**RE: 913 Silver Ave. SW**  
**Grading and Drainage Plan**  
**Engineer's Stamp Date: 07/25/19**  
**Hydrology File: K14D118A**

Re: Hydrology File #K14D118A, 913 Silver Ave. SW

I have attached a revised grading & drainage plan that addresses your comments of July 19, 2019. The comments have been addressed as follows:

C-101

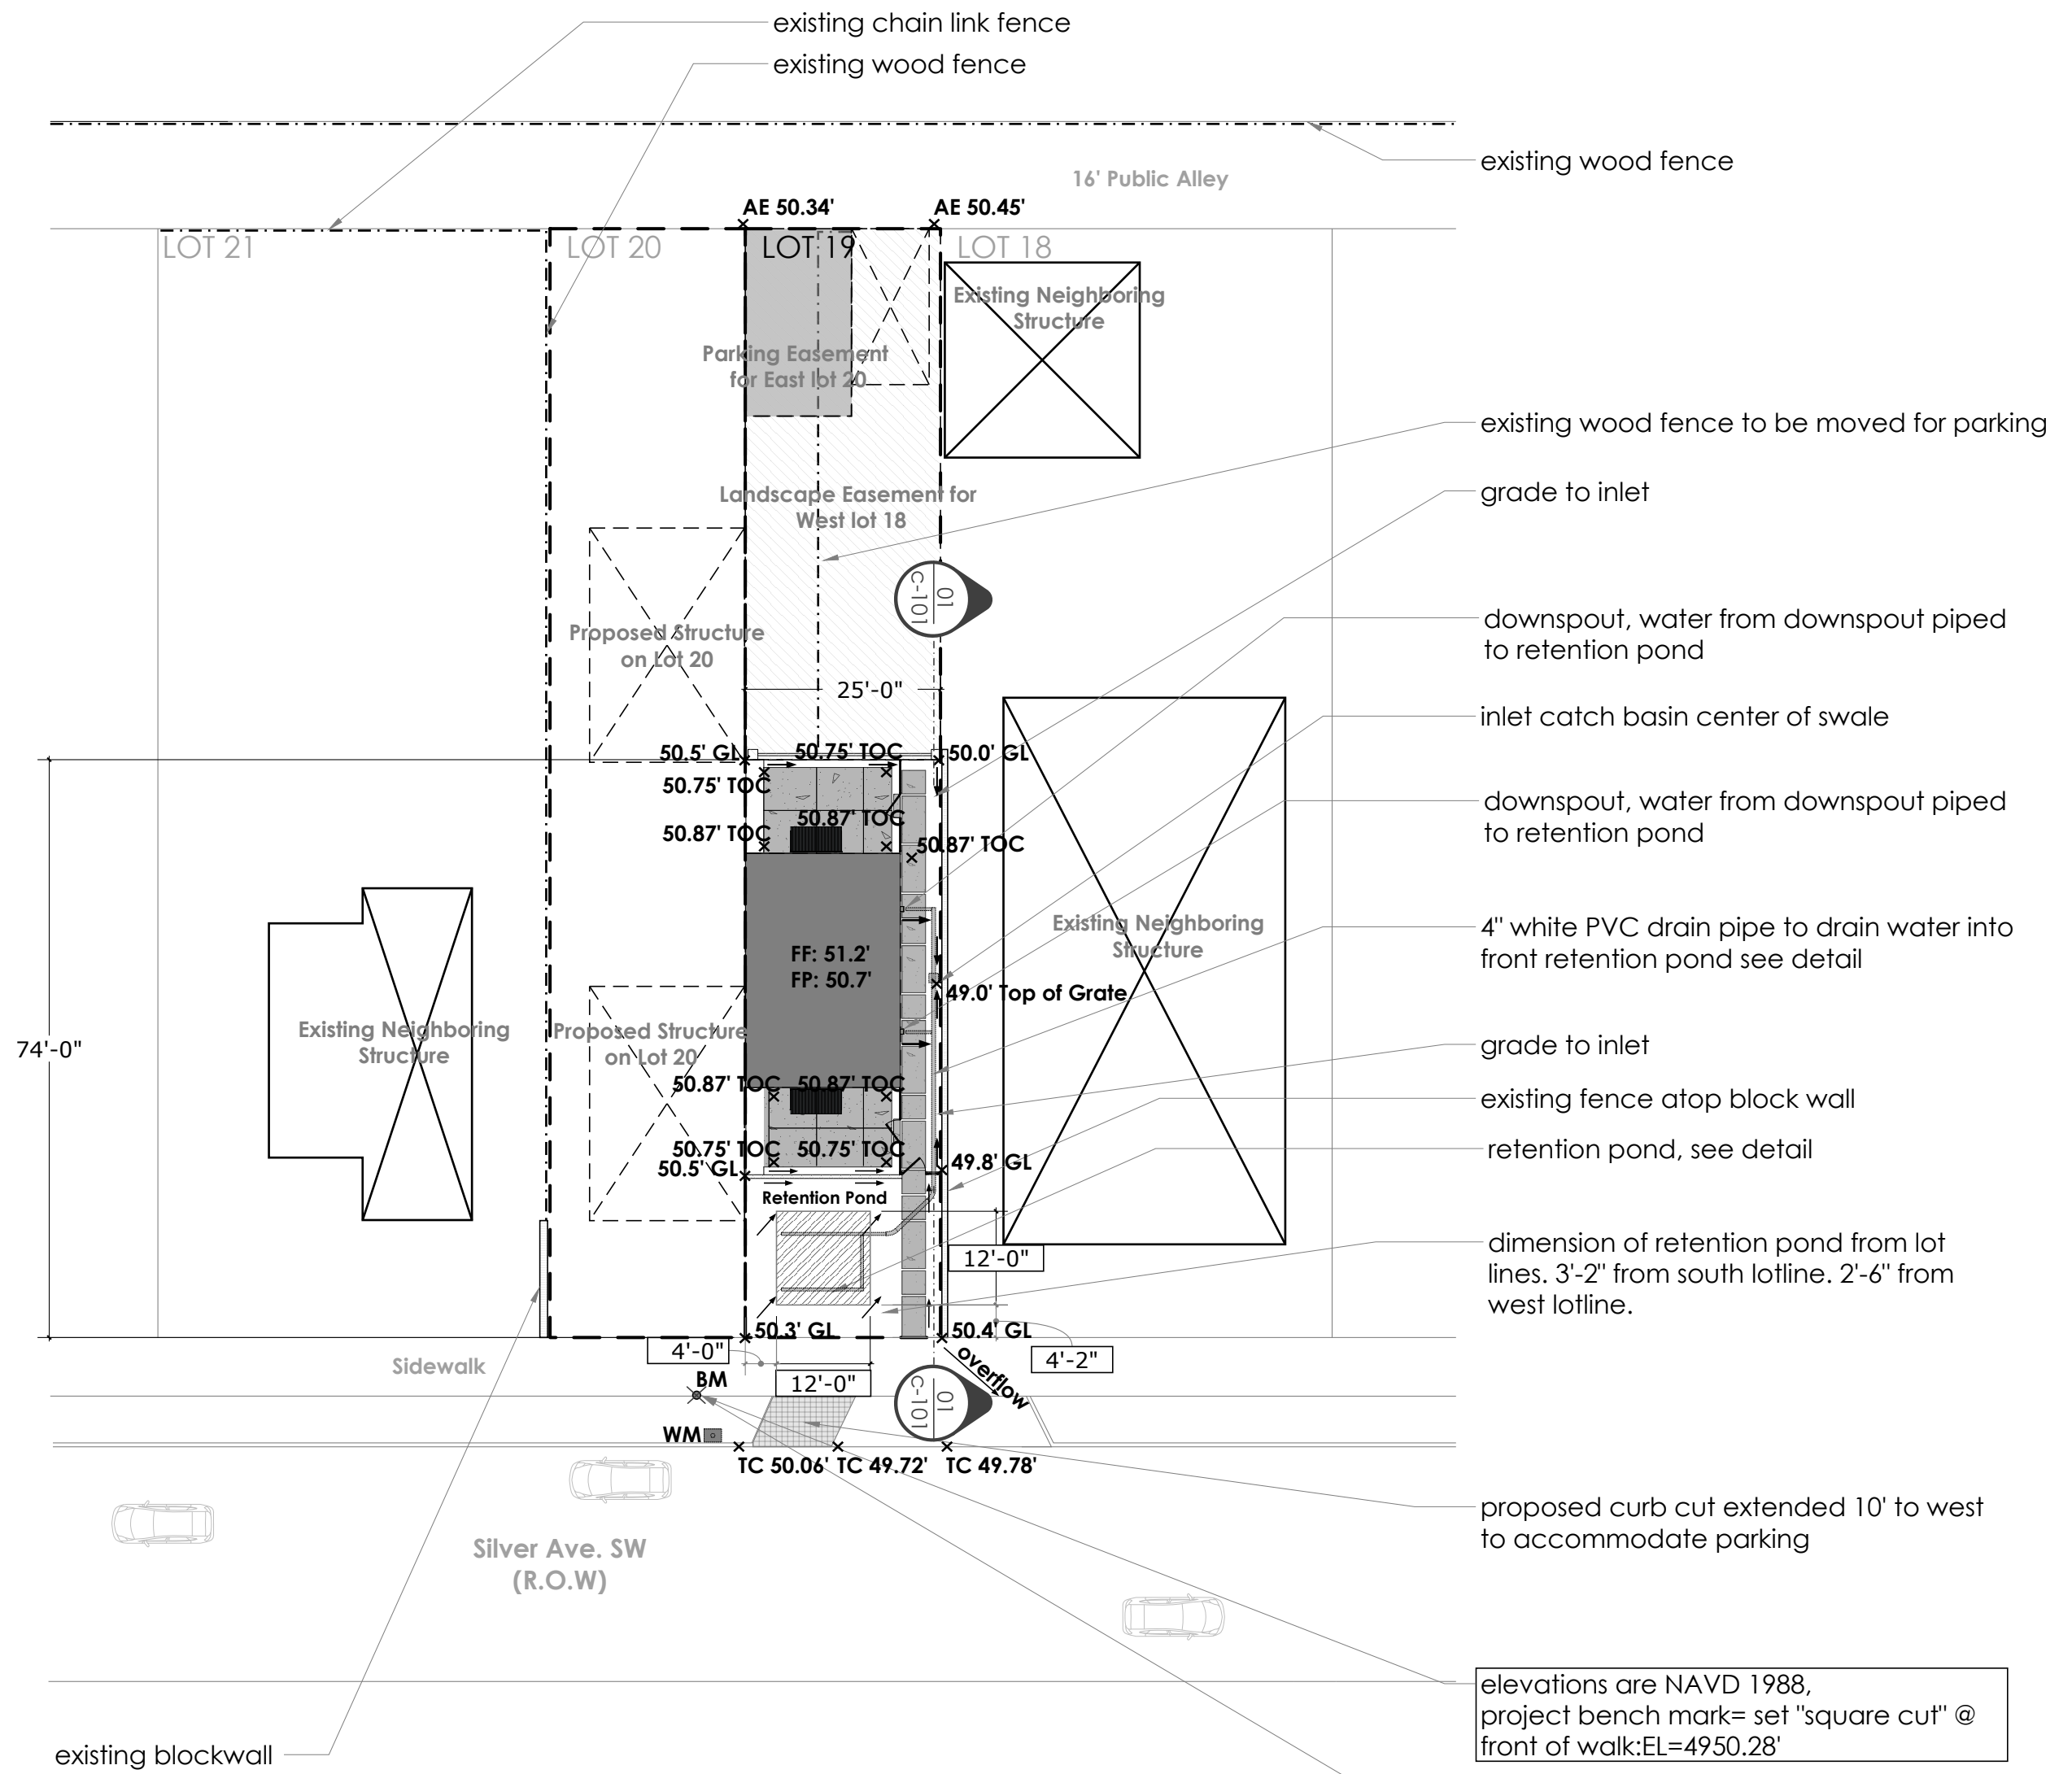
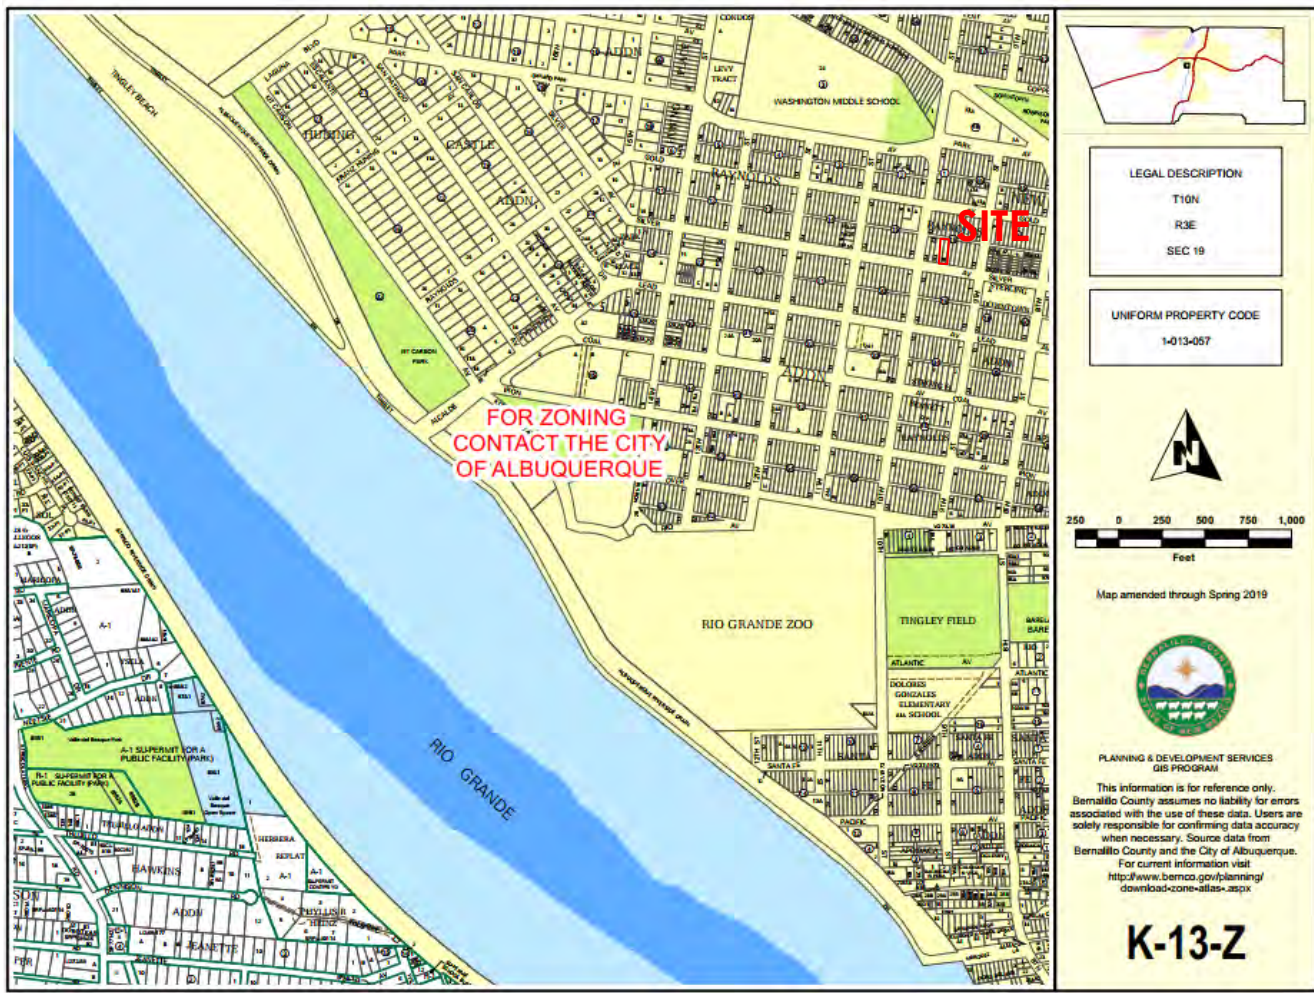
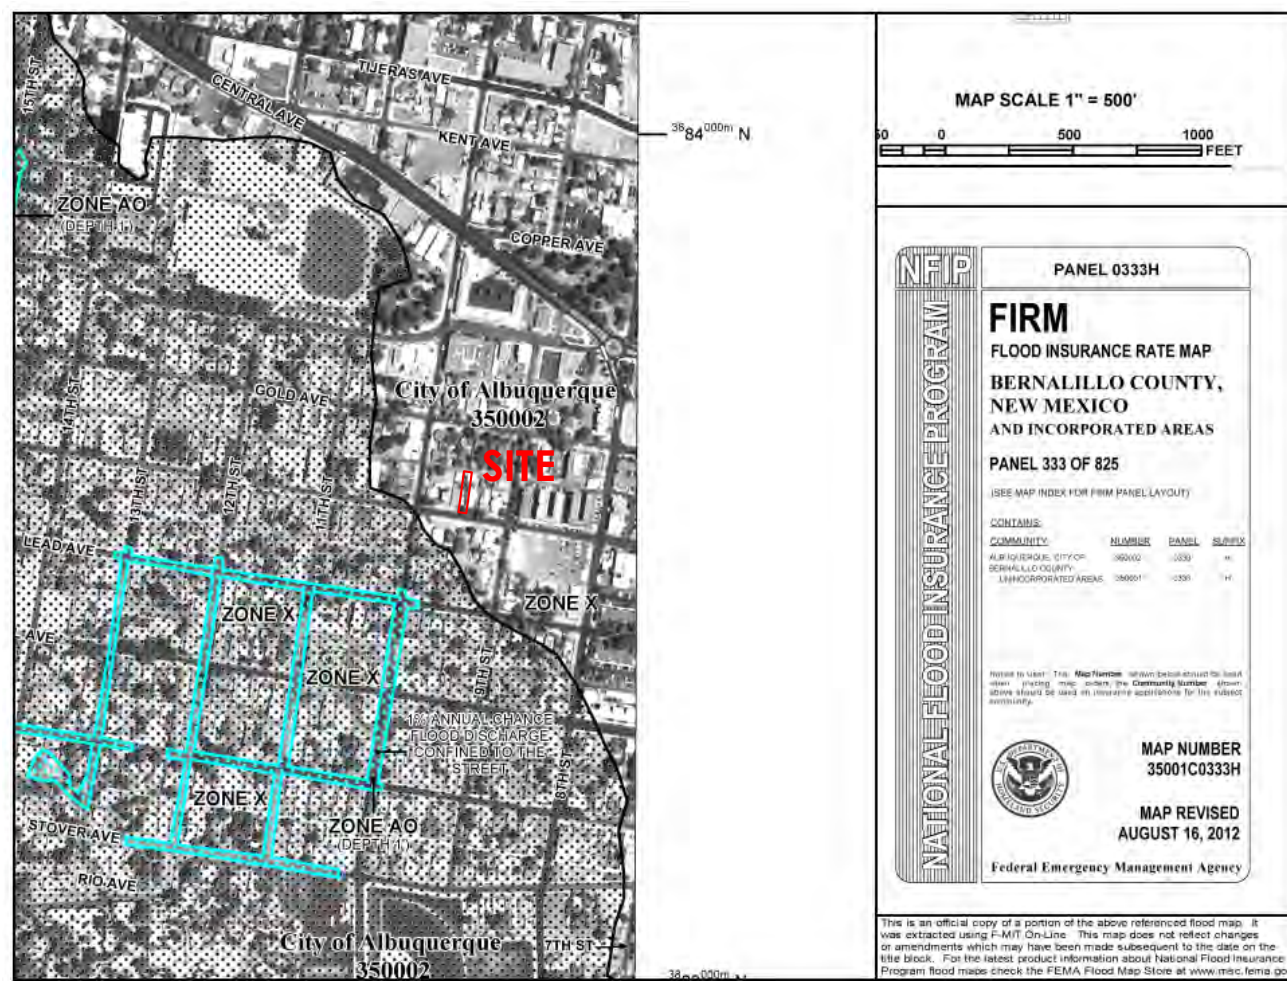
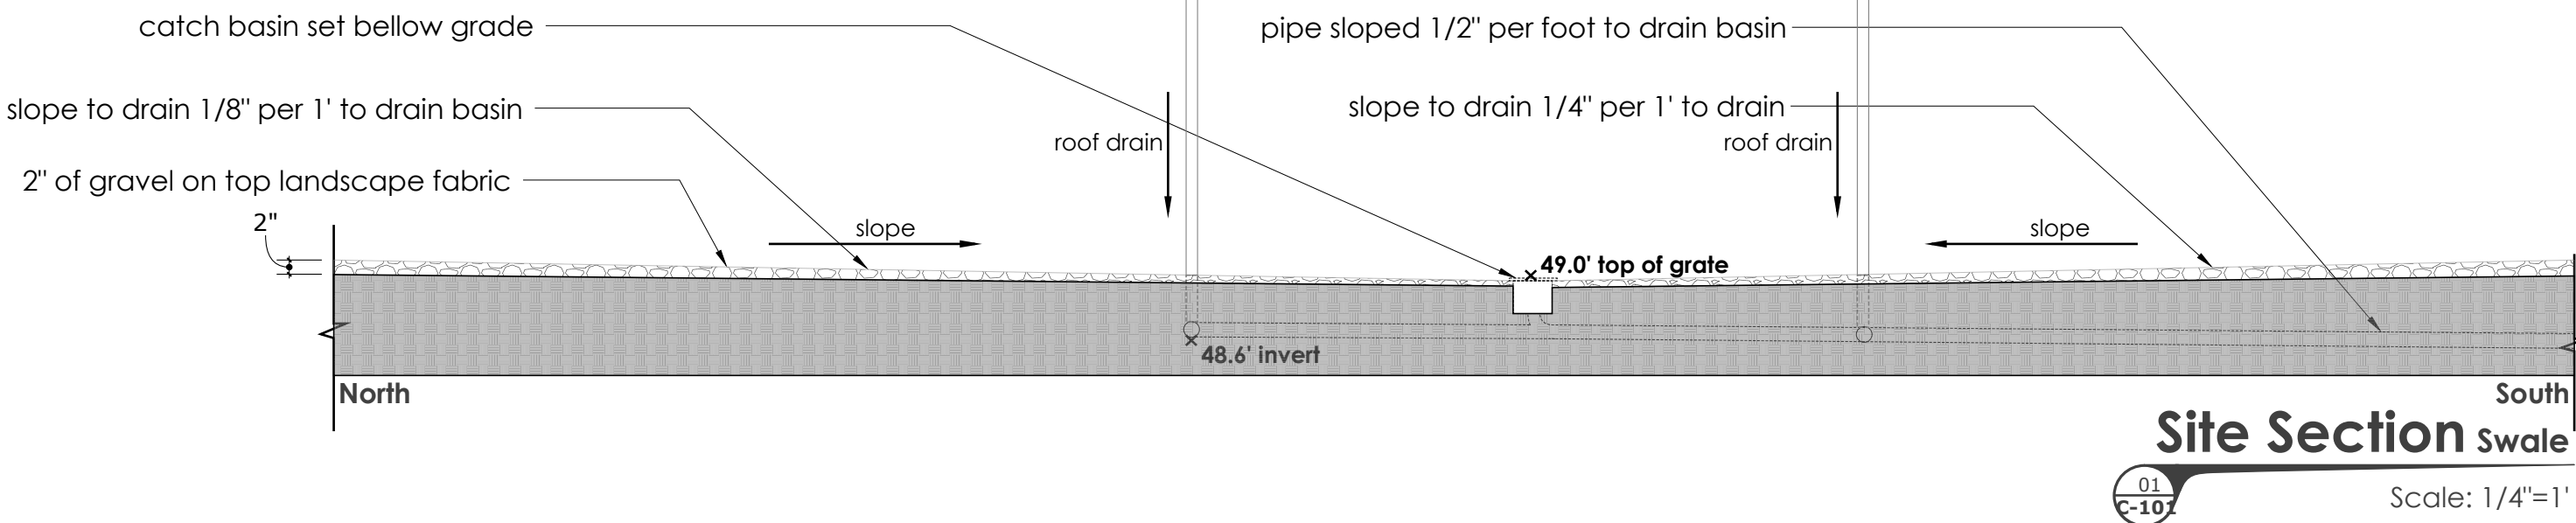
1. Even though the project benchmark is shown, please provide the City monument where this datum was taken. *The tie is presented on the plan.*
2. Per the DPM Chapter 22 Section 7 - Grading Plan Checklist, please use 1" = 20' for the scale. *The scale has been revised to 1"=20'.*

3. Per the DPM Chapter 22 Section 7 - Grading Plan Checklist, please provide a graphic scale. *A graphic scale has been provided.*
4. Please show all existing structures, fences, sidewalk, and pavement on the lot, adjacent lots, Silver R.O.W., and alley. These items are important to tie proposed grading into and are any going to remain. See aerial. *These items have been added and labeled on the plan.*

5. Please label both the alley as a "16' Public Alley" and Silver Ave SW R.O.W. *Labels have been provided.*
6. Please provide a legend showing all hatch patterns. I cannot tell what is being proposed. *Legend is provided.*

7. Please provide all dimensions needed to build the proposed retention pond especially the dimension off the property line. Also please label the retention pond. *The dimensions are now shown on the plan and labels have been provided.*

8. Please provide all dimensions needed to build the proposed French drain along the eastern property line especially the dimension off the property line. *An area drain pipe system is proposed in this area. It drains to the underground stormwater retention area.*

9. Please provide size of the drain pipe and proposed inlet rim elevations along with pipe inverts. *This information has been provided.*
10. Please provide the swale grades. *Spot elevations for concrete, swales and piping inverts have been provided.*

11. Since this site is in the Valley region, please follow Chapter 22 Section 5.G (Flat Grading Scheme). The following conditions must be applied to the site: *This plan proposes underground storage of the 100yr 6hr runoff volume. This was discussed with Mr. Doug Hughes prior to development of the plan.*

12. Please show how the overflow of 0.1 cfs is leaving the site from the retention pond. *The overflow location is shown on the plan.*
13. Please clarify the retention detail dimensions. Are these in inches or feet? Also please use aggregate instead of clean rounded cobble. *Dimensions have been provided. The clean rounded cobble is required to achieve the 30% porosity for the underground stormwater storage area.*

14. In the provided retention pond volume calculations, which dimensions are to be used in this project? There are five shown. *The developer has chosen the 15'x14'x4.5 configuration. This is shown on the plan.*

15. The site section does not provide any relevant information and can be removed. *The section now shows piping inverts and slopes for the proposed swale and area drain system as requested in 9 above.*
